CONVERSION TO ONE PIECE ALL ALUMINIUM “PADLESS” YOKE SLIDE ASSEMBLY

CATEGORY: Recommended At Next Overhaul

For further information about the Conversion to one piece all aluminium “padless” Yoke Slide Assembly, please contact either of the references at Carnaudmetalbox Engineering detailed below, quoting the technical bulletin number **TB5000-025**.

New Yoke Slide Assembly (Without bronze running pads)

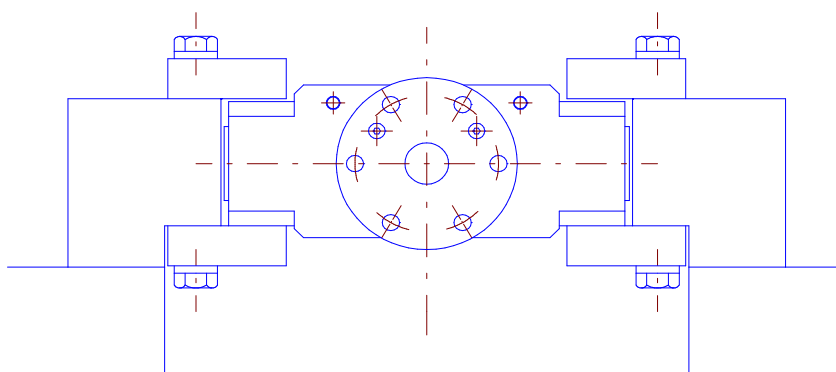
SUMMARY: CarnaudMetalbox Engineering has developed as part of the new mark II series 5000 Bodymaker an all aluminium one piece Yoke Slide Assembly which does not have any bronze running pads. This new arrangement provides for a simpler and more accurate design and eliminates the bronze pads which are often subject to corrosion attacks by acids formed in the lubricating oil.

An upgrade kit of parts is now available for all existing 5000 Bodymakers to convert to the new one piece aluminium “Padless” Yoke Slide.

This upgrade kit is applicable for all 5000 Bodymakers prior to machine serial No 195s.
